L. CENTER CLASSROOM ENTRIES & PARTITIONS PROJECT
CHESTERTON, INDIANA
gerometta & kinel architects, inc.

CLASSROOM MECH./ELECTRICAL REVISIONS
91-ME-04 B03, 04 YES, YES

REVISED POWER PLAN
BRUMMITT ELEMENTARY LEARNING CENTER #3 1/8"=1'-0"

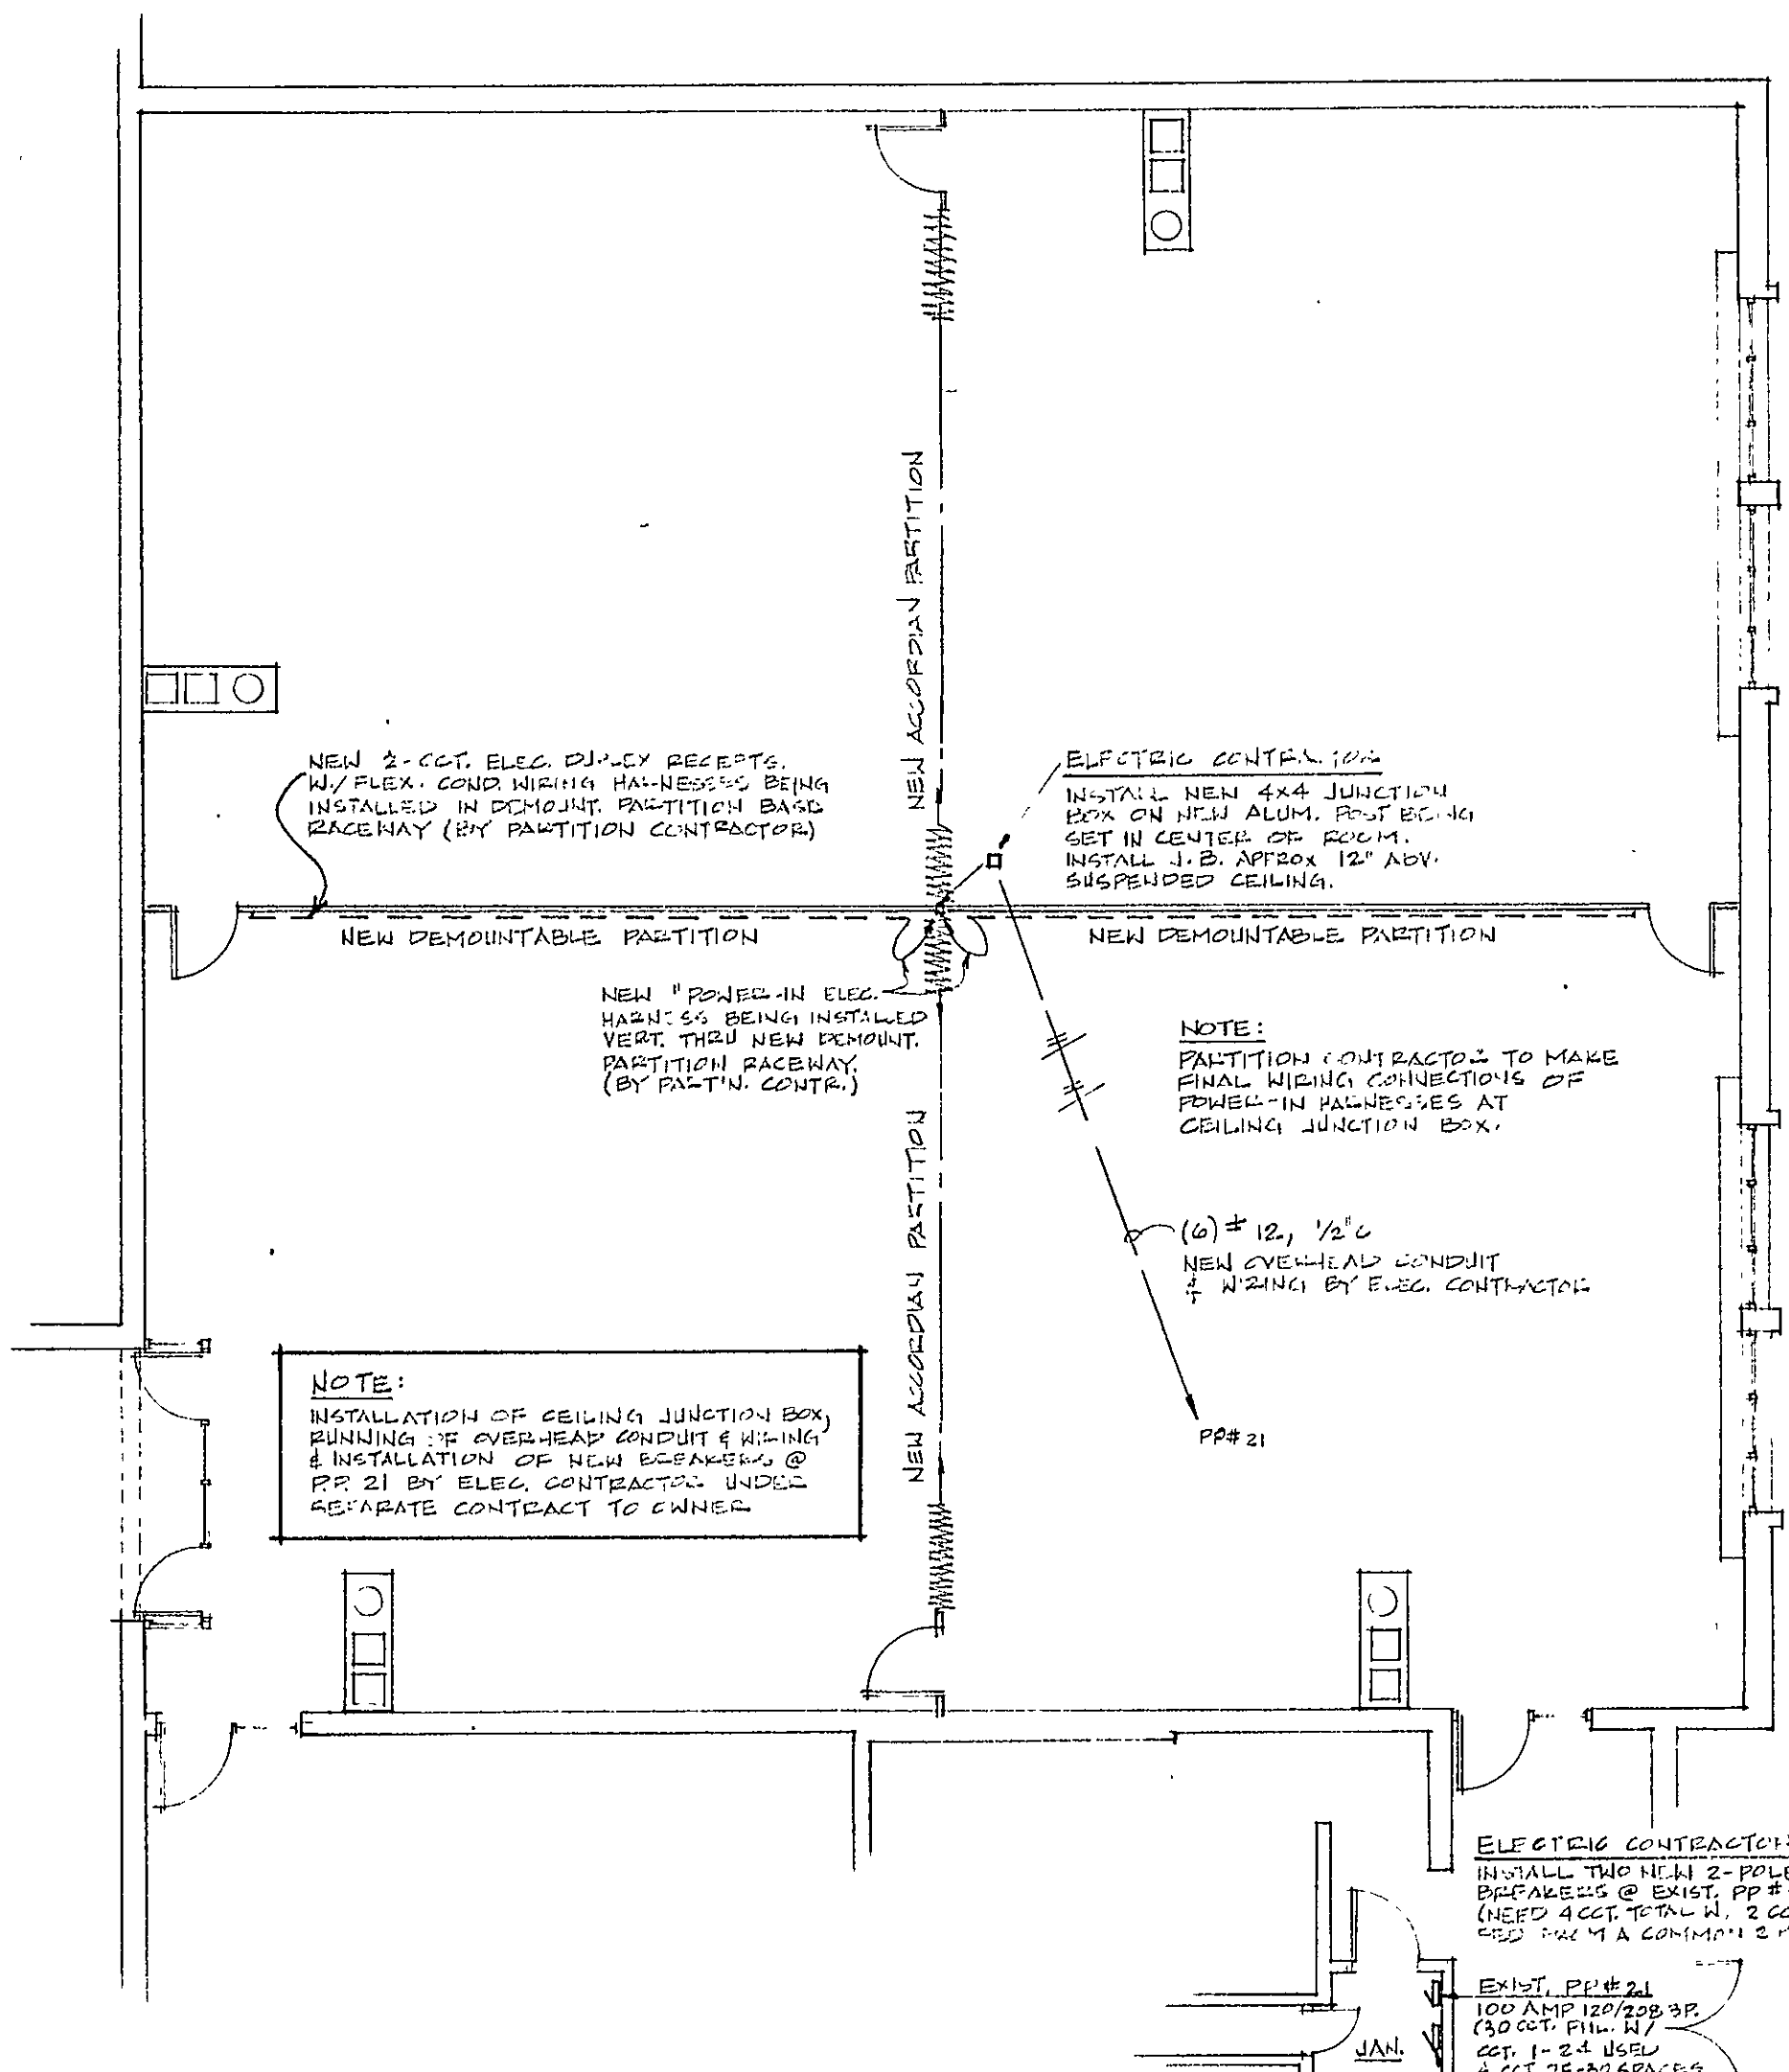
- Lighting/Emergency/switching/Clock modifications to Learning Center #3 as shown on Brummitt Lighting Plan this sheet.
- New Power Feed for electrification of new demountable partitions in Learning Center #3 as shown on Brummitt Power Plan this sheet.
- New Power Feed for electrification of demountable partition in Kindergarten - See Drwg. Sht. A-1 for location. (Single circuit feed from existing nearby power panel located in the Janitor/Utility Room to the West; similar to Learning Center #3 application, but only one circuit).
